From: "Pinto, Pat"
To: <andrewt@dnfsb.gov>
Date: 8/1/2011 5:40 PM
Subject: FW: Response to Communication Dated June 17, 2011 Regarding Safety Issues at the Waste Treatment Plant (WTP)
Attachments: CriticalReportFinal.pdf

A Critical Evaluation of Certain Aspects in the Design of the RPP-WTP Project

by A. Patrick Pinto

June 20, 2011

Figure 1: Proposed WTP Flowsheet

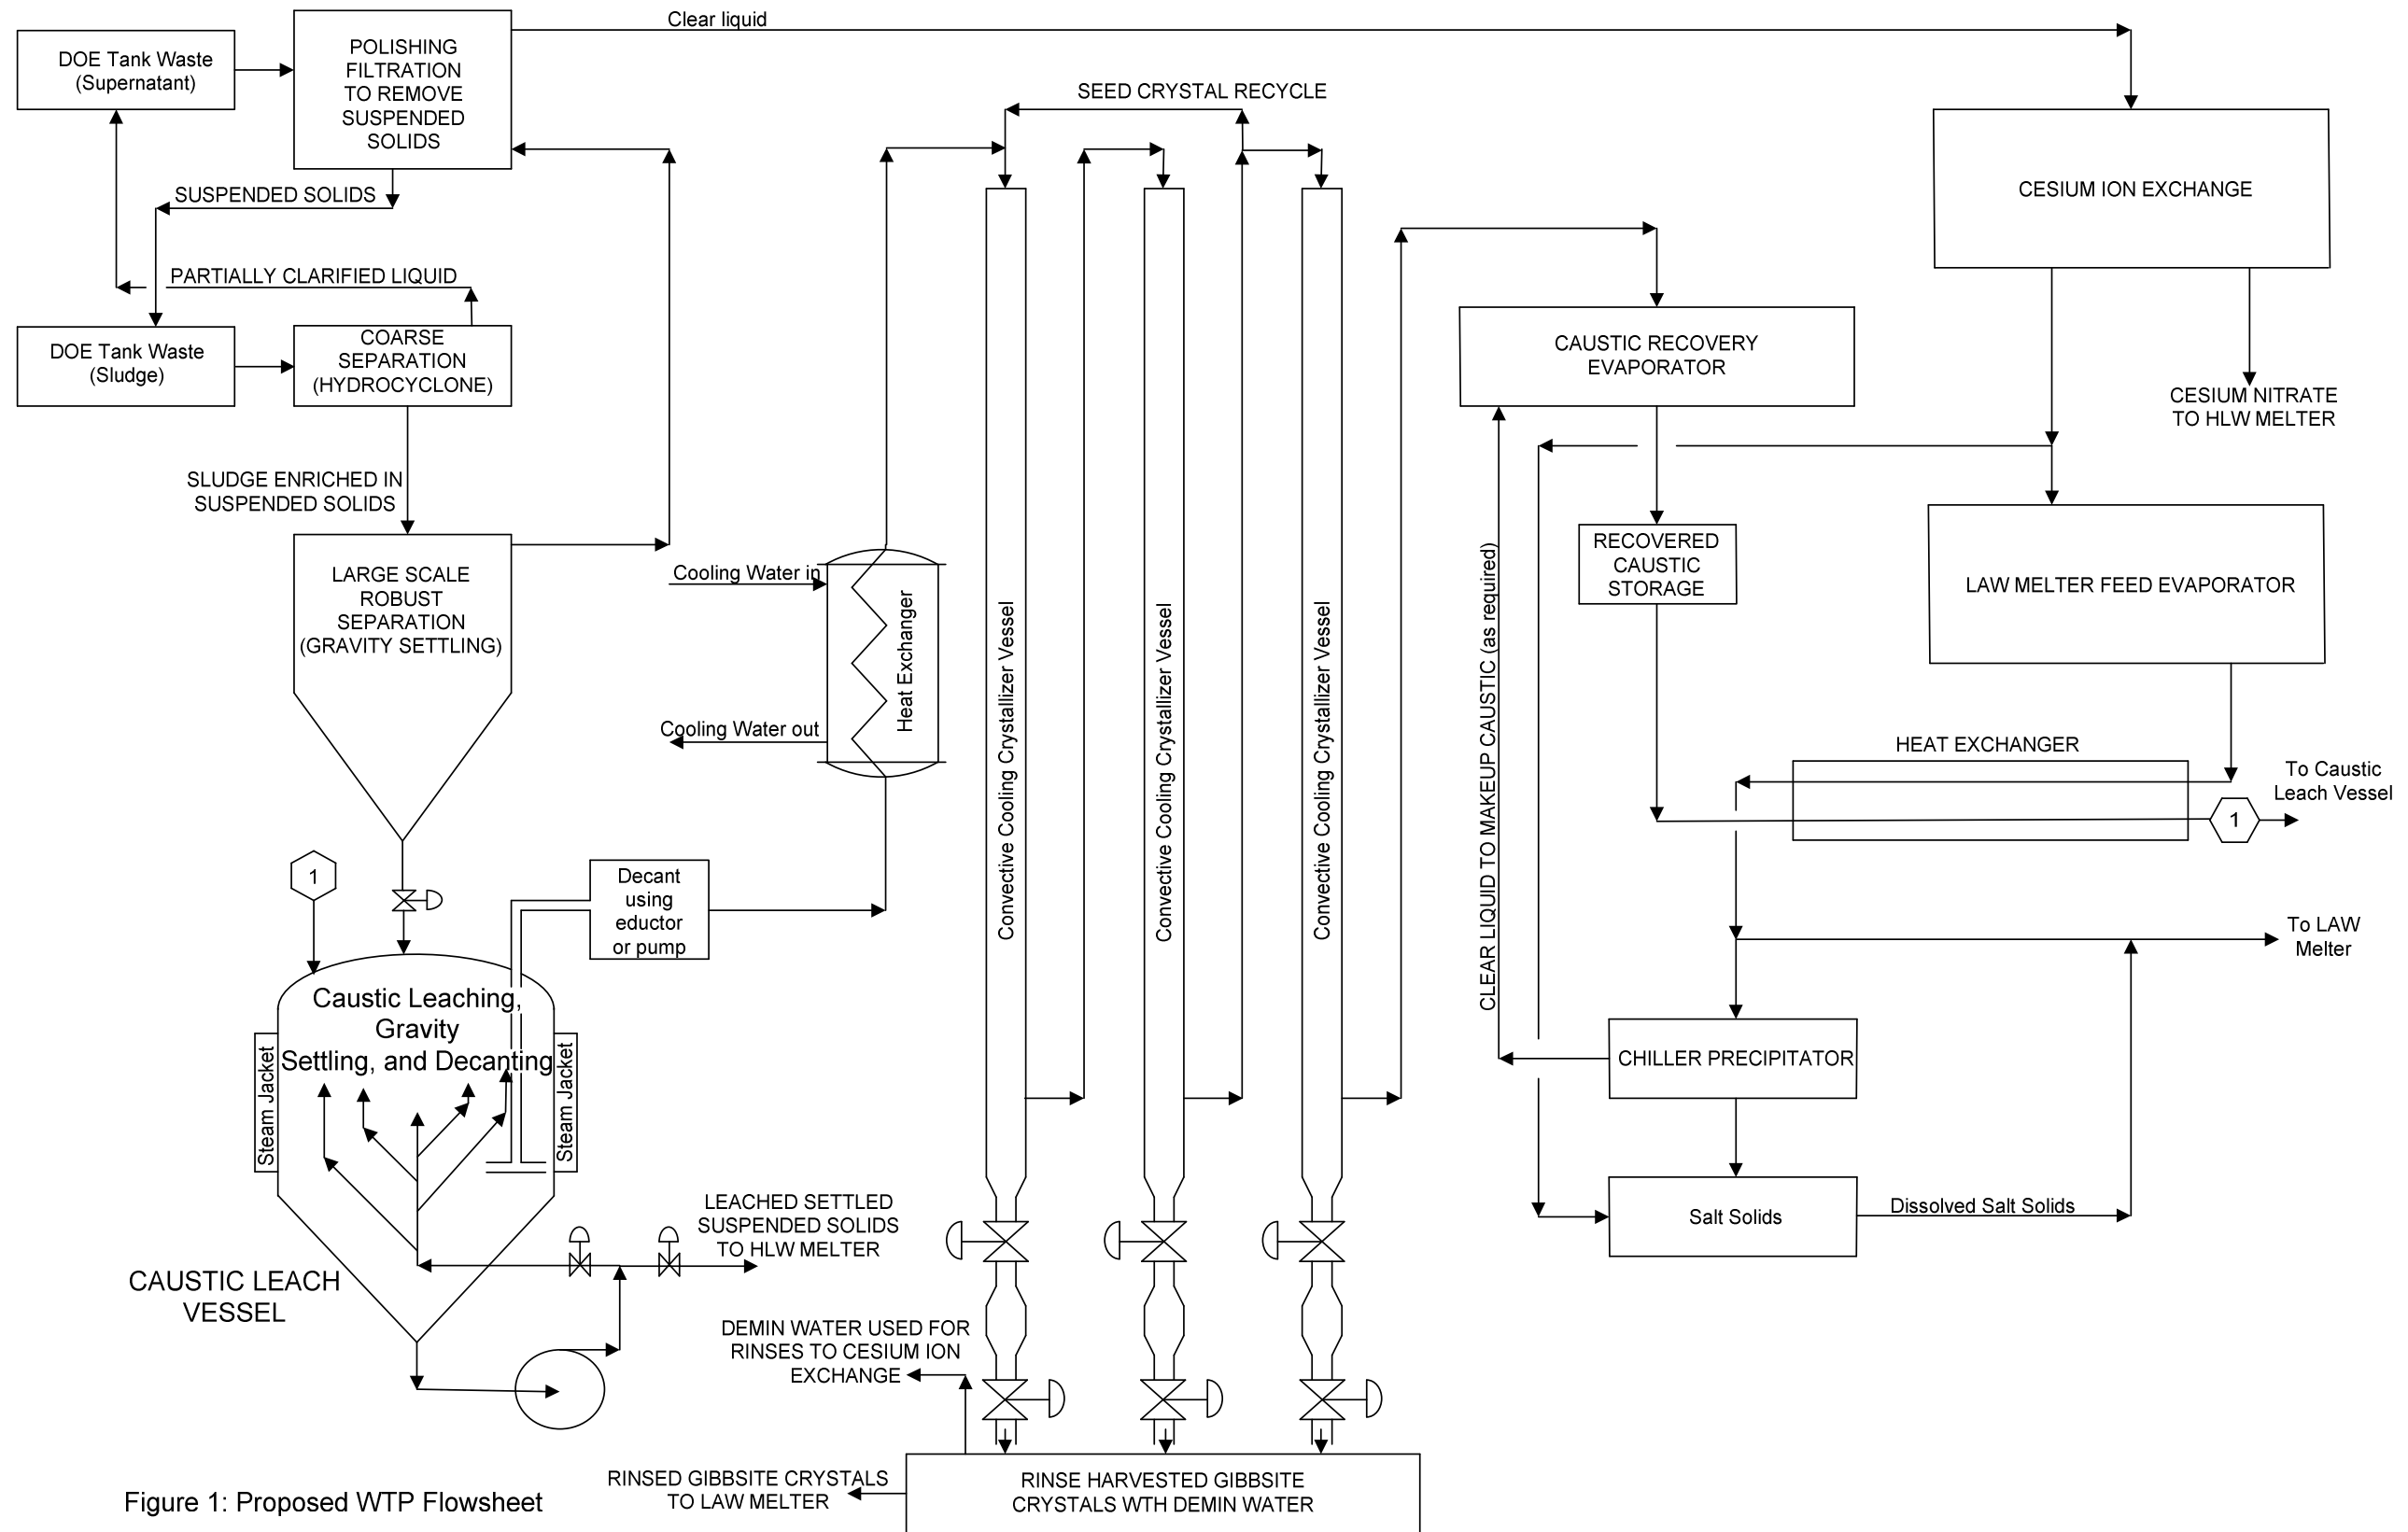
A gravity settler, taking up less than half the space used by the current ultrafiltration equipment in the black cell, was proposed earlier as a replacement process to concentrate the suspended solids. A small fraction of the hot cell installed ultrafiltration capability would be used to polish the overheads from the gravity settler, with the remaining large area in the hot cell currently taken up by the ultrafiltration equipment becoming available for other uses. The gravity settler bottoms (concentrated suspended solids) would be withdrawn continuously or periodically when the terminal settling concentration of the suspended solids is reached. Most of the suspended solids in the Hanford wastes settle rapidly, and those wastes that settle at a slower rate still settle fast enough to be concentrated in a gravity settler to much greater than the target 20% by weight that is planned for the ultrafiltration system. The concentrated suspended solids will be treated with hot sodium hydroxide in a conical bottomed steam heated reaction vessel also designed as a gravity settler. After treatment with hot sodium hydroxide, the clear liquid with dissolved aluminum will be separated from the treated suspended solids while still hot, and sent to thin long pencil shaped tanks where the crystals of gibbsite form and grow. The larger gibbsite crystals will settle to the bottom of the thin pencil shaped tanks, leaving behind the clear liquid which will be concentrated in an evaporator and reused to dissolve the aluminum in the next batch of concentrated suspended solids. The sodium hydroxide used to dissolve the aluminum thus does not end up becoming radioactive waste glass. Figure 1 is a process flow diagram of the above described process.
